Proposed Design & Construction Standards Manual Amendments

Section 2.6.10

REVISIONS				BICYCLE PARKING DETAIL (TYP.)	DWG. NO.
NO.	DATE	DESCRIPTION	INIT.		2.6.10
					PAGE
					1 OF 2

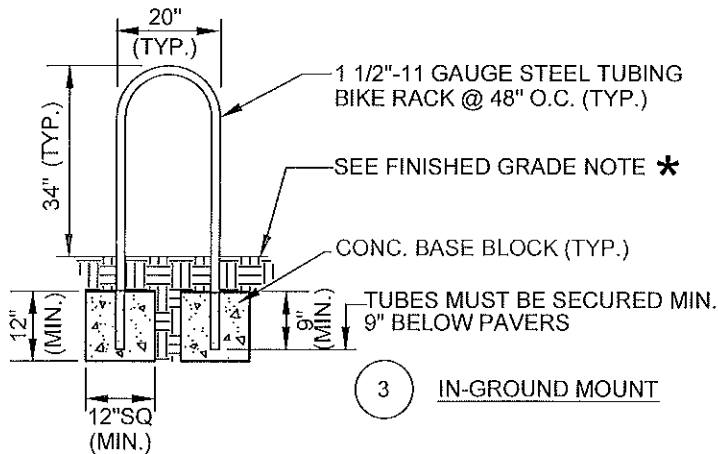
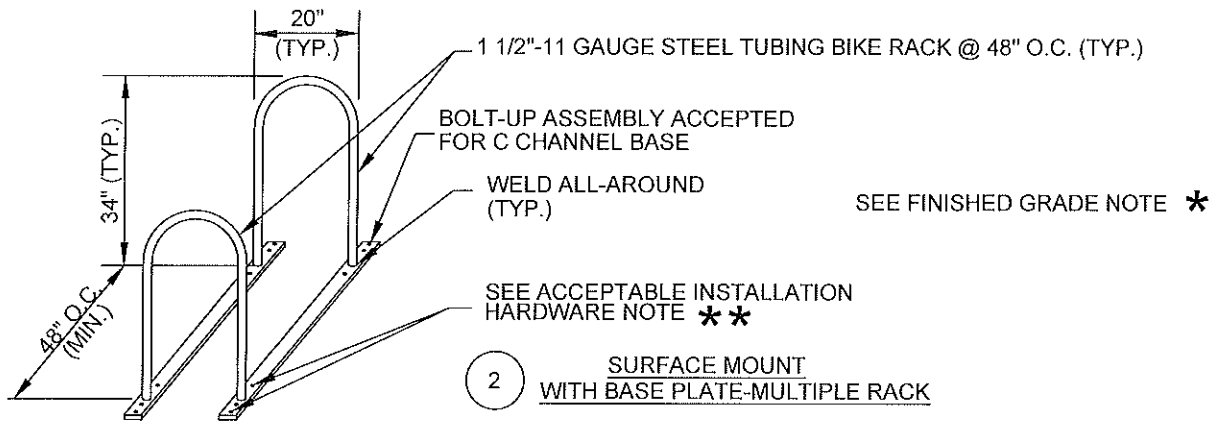
~~Developments with 15 or greater car parking spaces shall provide exterior parking for bicycles at a rate of one bicycle space per 25 car parking spaces, with a minimum of 4 bicycle spaces. Bicycle parking shall be in the form of a suitable bike rack(s), conveniently located, visible and anchored for security. Protection from the elements is encouraged. Rack design and layout shall be as recommended in the document "Bicycle Parking Guidelines" as adopted by the Association of Pedestrian and Bicycle Professionals (www.apbp.org). Rack location and type shall be specified on the project site plan.~~

Plans shall include bicycle parking details to address zoning requirements. Such details shall include the location, design, and spacing of bicycle parking on site.
